Re: USACE File No. NAE-2019-02150
Remedial Activities Project
Former Tidewater Facility
200 Taft Street
Pawtucket, Rhode Island

As we have discussed during the past few weeks, GZA GeoEnvironmental, Inc. (GZA), on behalf of The Narragansett Electric Company d/b/a National Grid (National Grid), is seeking approval of certain modifications to the approved, on-going Remedial Activities at the Former Tidewater Facility located in Pawtucket, Rhode Island (herein referred to as the Site).

Given the observed coal tar impacts in certain areas, we are seeking approval to modify the revetment cap design in the northern portion of the Site between Stations 4+00 and 5+95 (approximately 195 feet along the shoreline) to minimize the disturbance of coal tar impacted soil and the risk of a potential breach in the controls (turbidity curtains and absorbent booms) installed within the river. Instead of disturbing and excavating in these impacted areas, fill consisting of stone, RCM, woven and non-woven geotextiles, and riprap will be placed on top of the surface of the impacted sediment, all below MHW and the High Tide Line (HTL). The slope of the bottom sediment will also be adjusted accordingly –

ALTERNATIVE REVEMENT LAYOUT PLAN

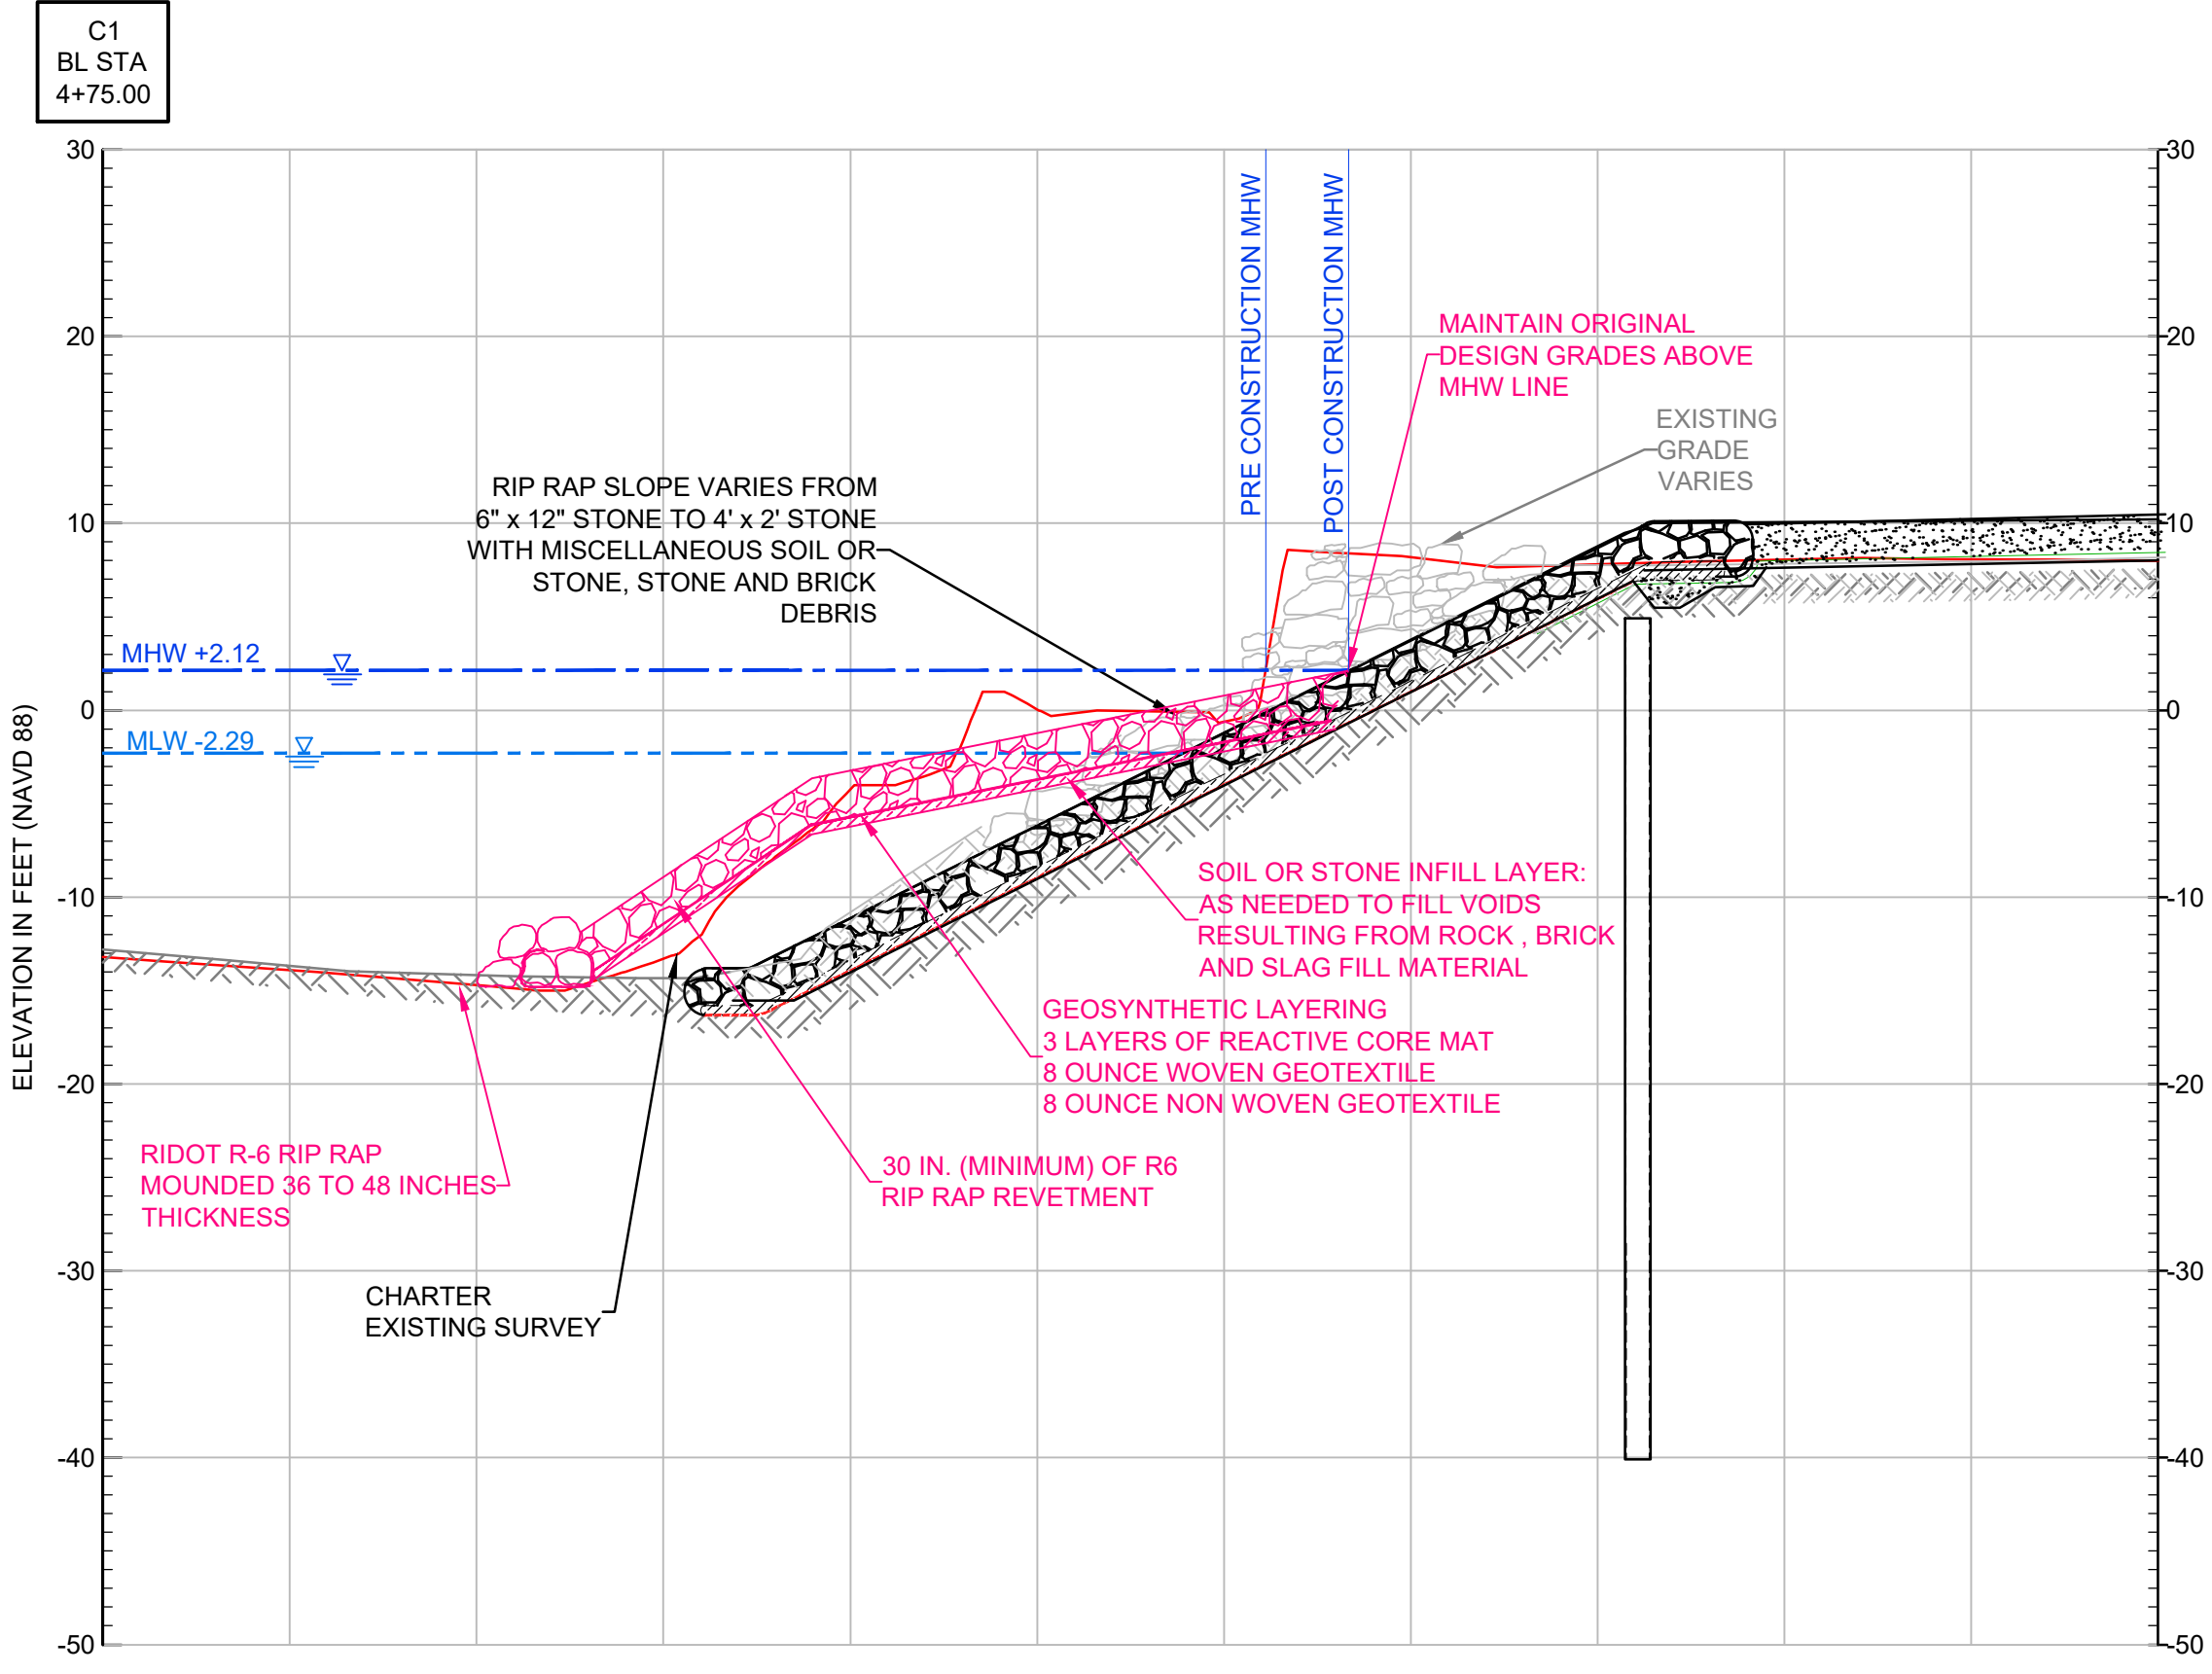
extend several feet beyond what was anticipated within the 2019 permit. The existing riverbank above MHW will be regraded consistent with the original permitted design. The final result for the overall project will be a decrease in the amount of dredged material and an increase in fill replacement compared to the approved permit values. Approximate areas and distances are as follows:

Attribute	NAE-2019-02150 Permit Value	Proposed Modified Value
Dredging seaward of MHW for revetment cap (square feet)	18,400	16,600
Sheet Pile Wall seaward of MHW (linear feet)	550	550 (no change)
Rip Rap Revetment seaward of HTL (square feet)	12,900	14,700
Clean fill between existing seawall and new sheet pile wall seaward of HTL (square feet)	5,500	5,500 (no change)
Permanent discharge of rip rap for sheet pile wall armoring seaward of HTL (square feet)	3,950	3,950 (no change)
